Battersea Park Action Group
c/o 74a Prince of Wales Mansions
London
SW11 4BJ

Planning Application (2016/3064)

Battersea Park – Restoration of Formula E Alterations

APPENDIX 1 – Reinstatement analysis

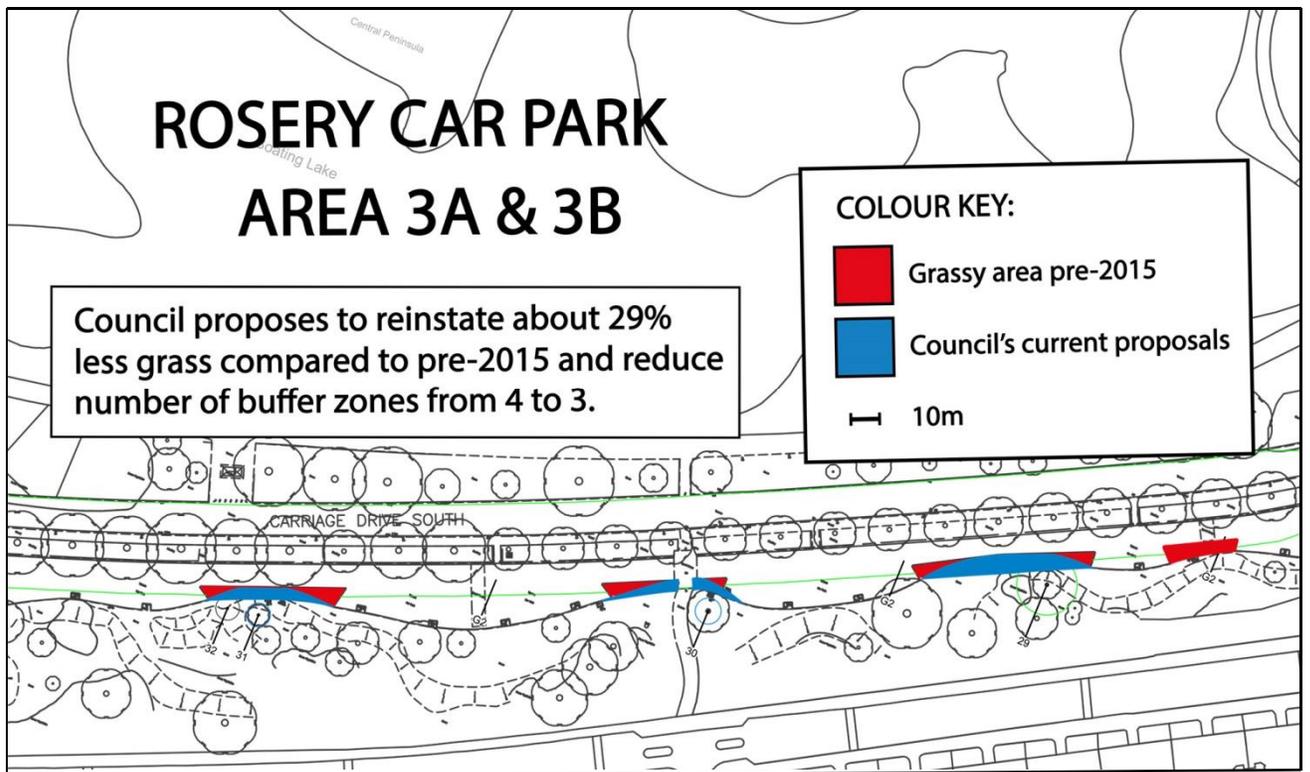
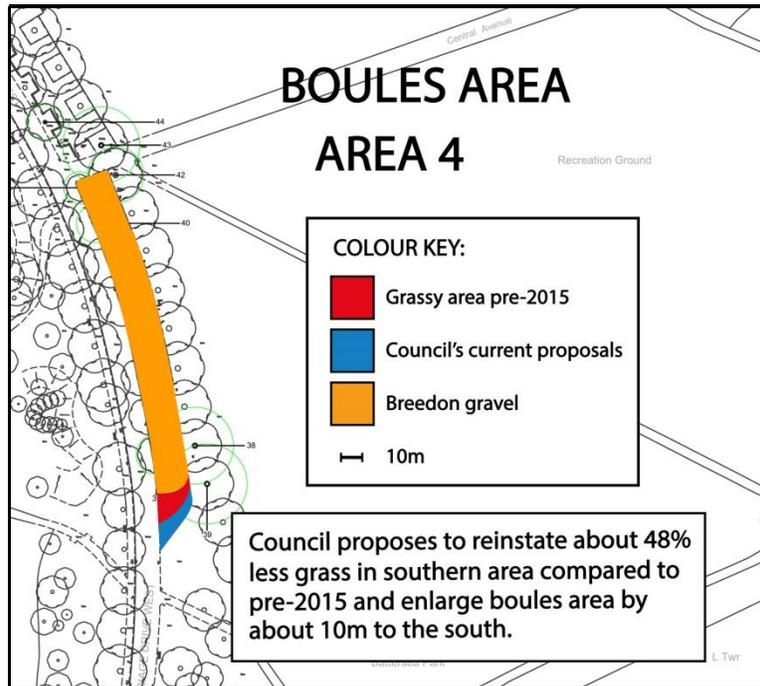
The plan in **APPENDIX 1** below illustrates that the applicant is seeking to reduce the **four** green zones between the various parts of the Rosery car park down to **three**. Furthermore they are to be reduced in size. There can be no public benefit in such a proposition. Previously there were five distinct car park areas with narrower link roads between. The current proposals gives the impression of one long car park (**See Photo 1***). This is totally out of keeping with the park landscaping and by officers own admission causes harm to the heritage layout of the park. These proposals we understand are being driven by the commercial considerations of Enable LC and not Formula E.

- **Ensure the extent of the boules area is returned to its former layout such that both blue & red areas shown in APPENDIX 1 are returned to grass.**
- **Ensure that the Rosery car park green buffer zones are reinstated to their former extent, re-profiled and that four not three areas are retained.**
